MFN 06-274

Subject: Response to RAI Letter Number 20 Related to ESBWR Design Certification Application – Seismic Design – RAI Numbers 3.7-16, 3.7-24, 3.7-27, 3.7-30, 3.7-32, 3.7-33, 3.7-35, 3.7-37, 3.7-38, 3.7-39, 3.7-50, 3.7-54 and 3.7-57

**Response to NRC RAI Letter No. 20 Related to ESBWR Design
Certification Application**

Shimizu Engineering Report																	
Project	General Electric Company ESBWR Project		Shimizu Document No.	SER-ESB-033													
Title	Parametric Evaluation of Effects on SSI Response		Rev.	0													
			Issued Date	8/14/06													
			Revised Date														
<p>NOTE:</p> <p>This document provides additional SSI analyses performed and results obtained for the Reactor/Fuel Building Complex (RBFB) the Control Building (CB) to address the following issues identified in RAIs.</p>

Figure 7.4-1 Lateral Soil Pressure - RBFB R1 and F3 Wall

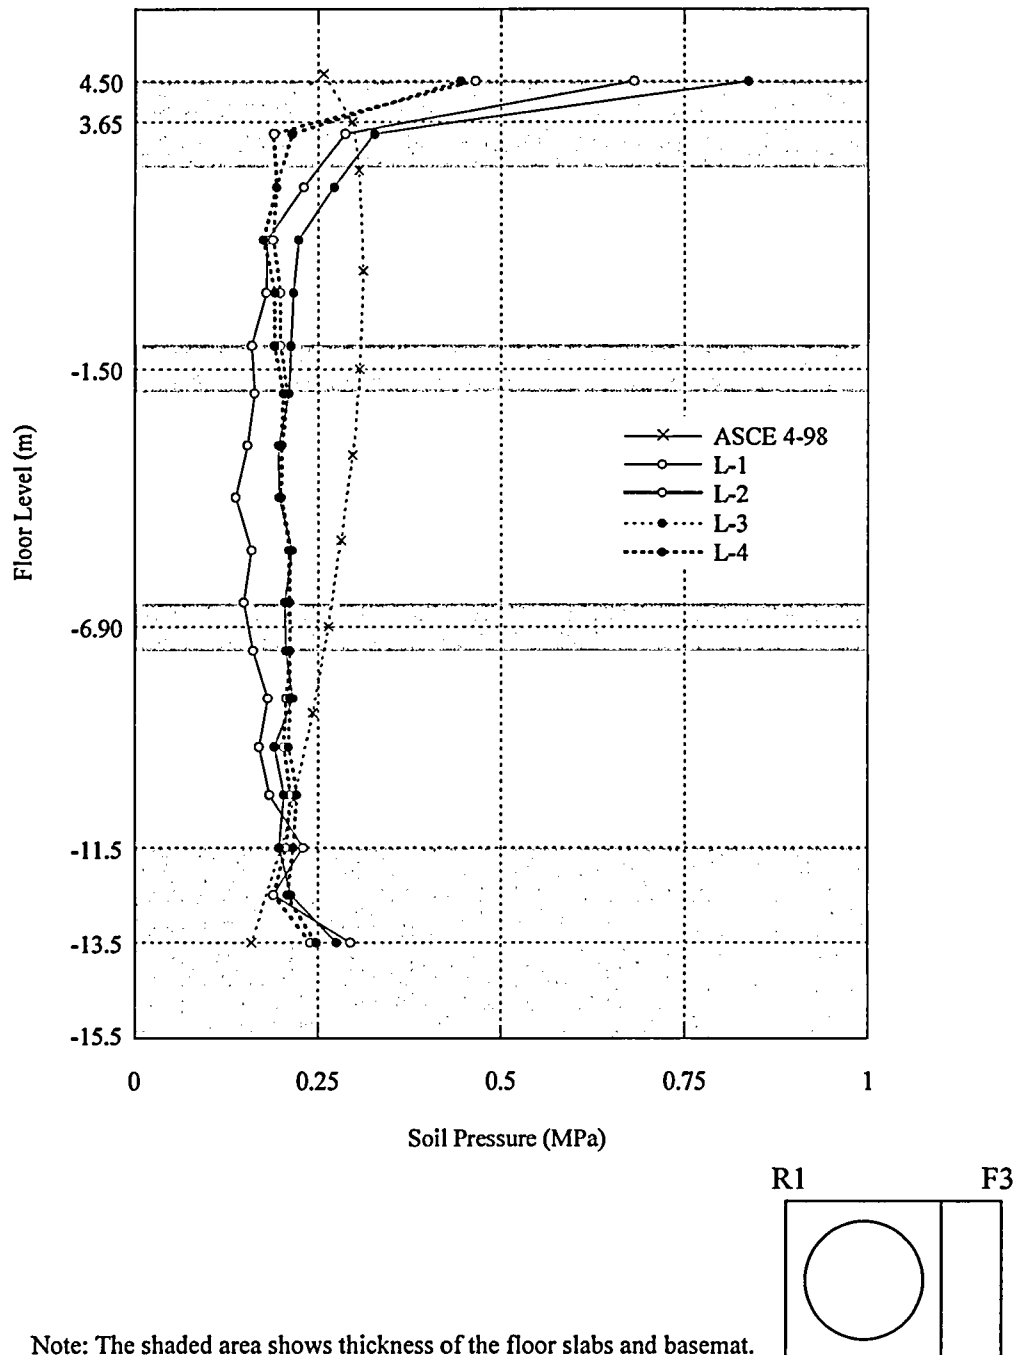
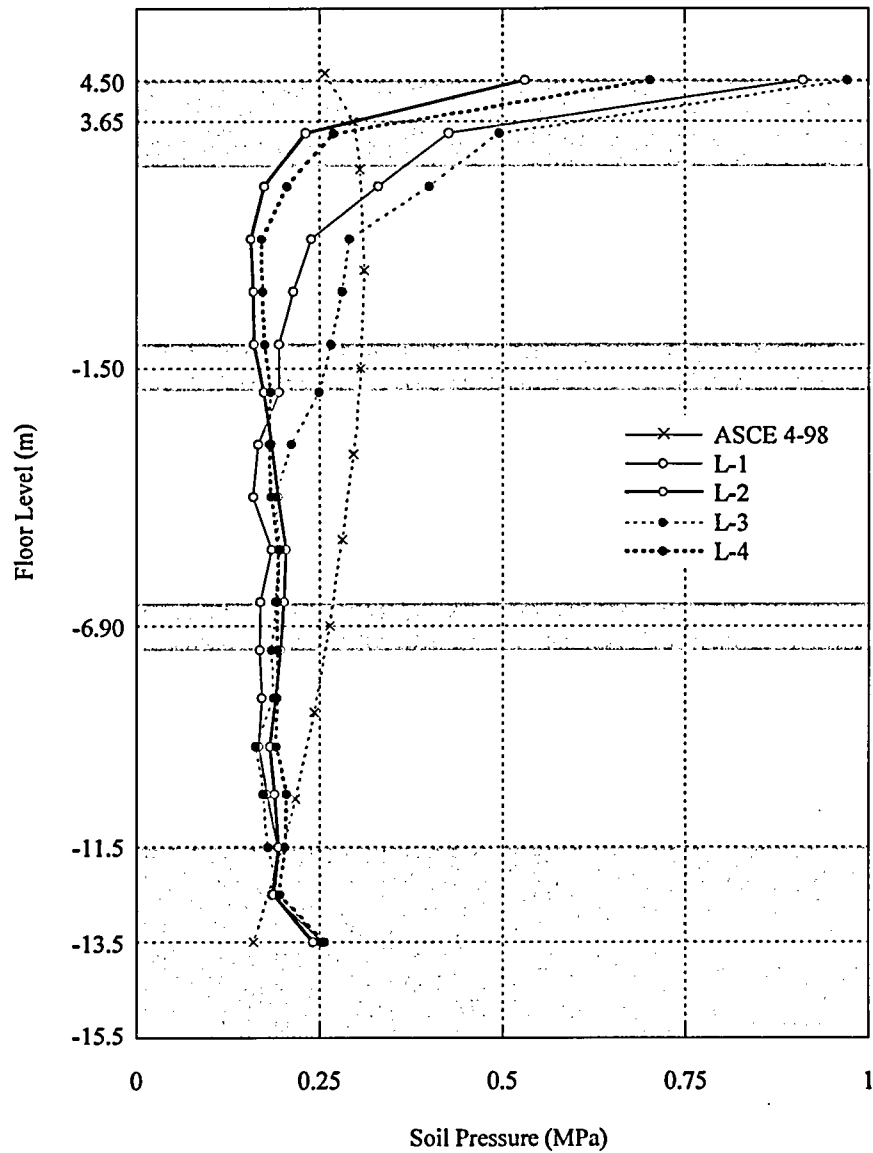
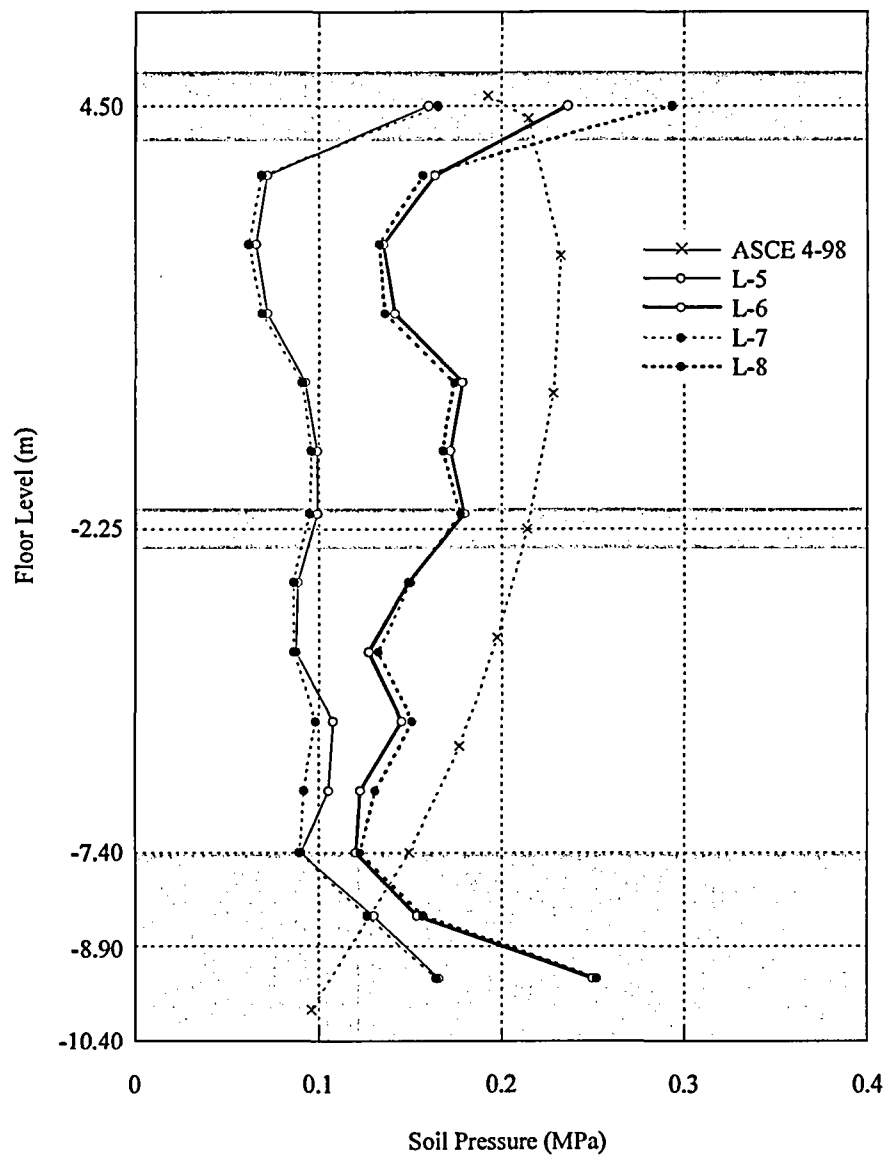
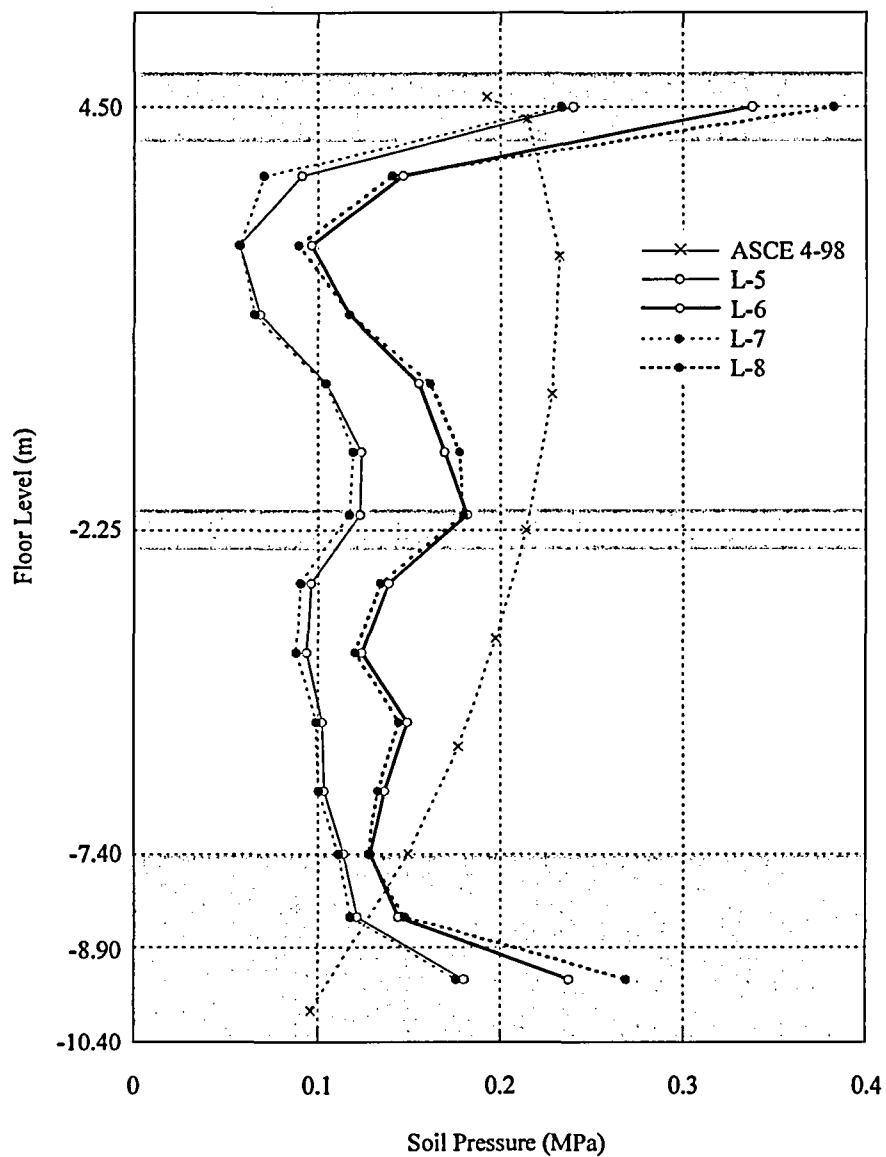
DCD Section 3A.5 indicates that the use of lateral pressures computed from the equivalent static pressure analysis listed in ASCE 4-98 is conservative. Based on reviews of a number of facilities, it is known that actual pressures computed from detailed SSI evaluations of embedded foundations are directly influenced by the characteristics of the foundation response spectrum used to define the ground motions as well as the relative stiffness (shear wave velocity) of the soils above the basemat level. The staff requests the applicant clearly indicate in the DCD either (1) the technical basis for the statement that these static pressures are conservative for any site, or (2) any limitations that need to be incorporated into the acceptable site profile characteristics to limit the actual dynamic pressures anticipated.

In the existing DCD, the lateral pressure computed from the equivalent static pressure analysis listed in ASCE 4-98 is used for the design soil pressure. To confirm the ASCE 4-98 method is conservative, the soil pressures calculated from the SASSI analysis for the layered sites described in Section 7.2 was compared with the ASCE 4-98 method soil pressures in Figures 7.4-1 through 7.4-4.

It is found from the results that the SASSI soil pressures are generally bounded by the ASCE 4-98 soil pressures; however, at the elevation close to the ground surface and the basemat elevation, the SASSI soil pressure exceeds the ASCE 4-98 soil pressure. The design soil pressure loads for the exterior walls are calculated by averaging soil pressures which each wall is subjected to. The calculated design soil pressures are summarized in Tables 7.4-1 and 7.4-2, comparing between the SASSI soil pressures and the ASCE 4-98 soil pressures. The envelope of the two values will be used for the exterior wall design.
